16/01797/1: Land Rear Of 4-14, Claybush Road, Ashwell, SG7 5RA - Proposed Residential Development Claybush Road, Ashwell –

An independent review of the applicants Transport Statement

This note provides an independent review of the Transport Statement (TS) undertaken by WSP/Parsons Brinkerhoff on behalf of Croudace Homes, for the proposed residential development comprising 33 dwellings at land to the rear of 4-14 Claybush Road, Ashwell, Hertfordshire.

Figure 1 – Extract of Hertfordshire County Council PRoW map.

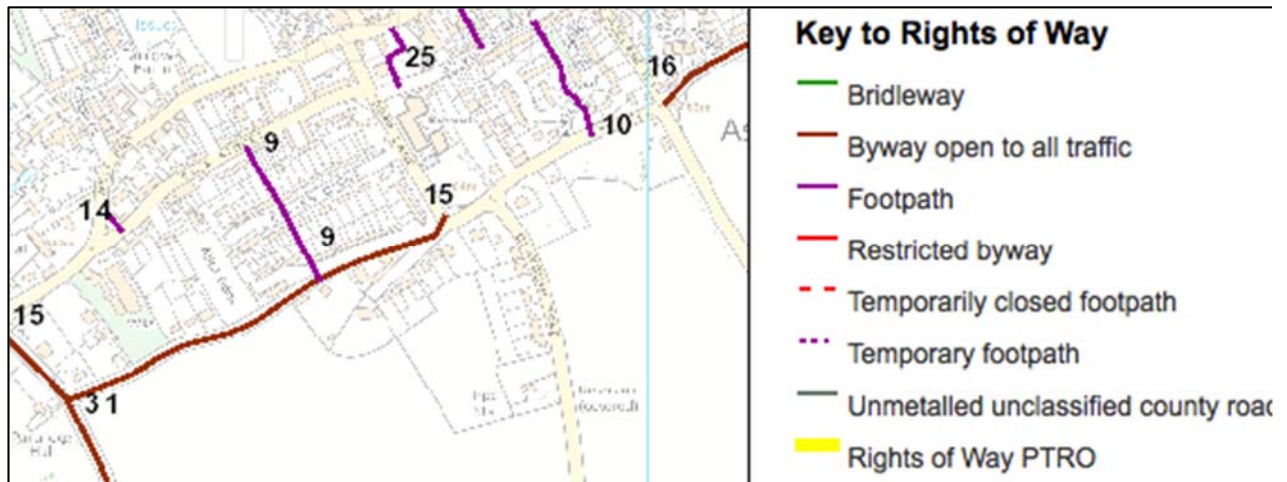
north of the site. However following consultation with Ashwell Parish Council it is understood that access rights do not exist over Ashwell Street, which is also further confirmed from Hertfordshire County Councils (HCC) PRoW map. Access rights are clearly required, especially when standard formal footways do not exist on Claybush Road. Existing PRoW in the vicinity are detailed at **Figure 1**.

Furthermore the TS however does not indicate any creation, modification or off-site improvements to the 'PRoW' which it is assumed will remain (that is if indeed the proposed link is a PRoW) as an unlit and unpaved grass path between the proposed site and Ashwell Street. Such a situation is wholly inappropriate and should be considered unsafe.
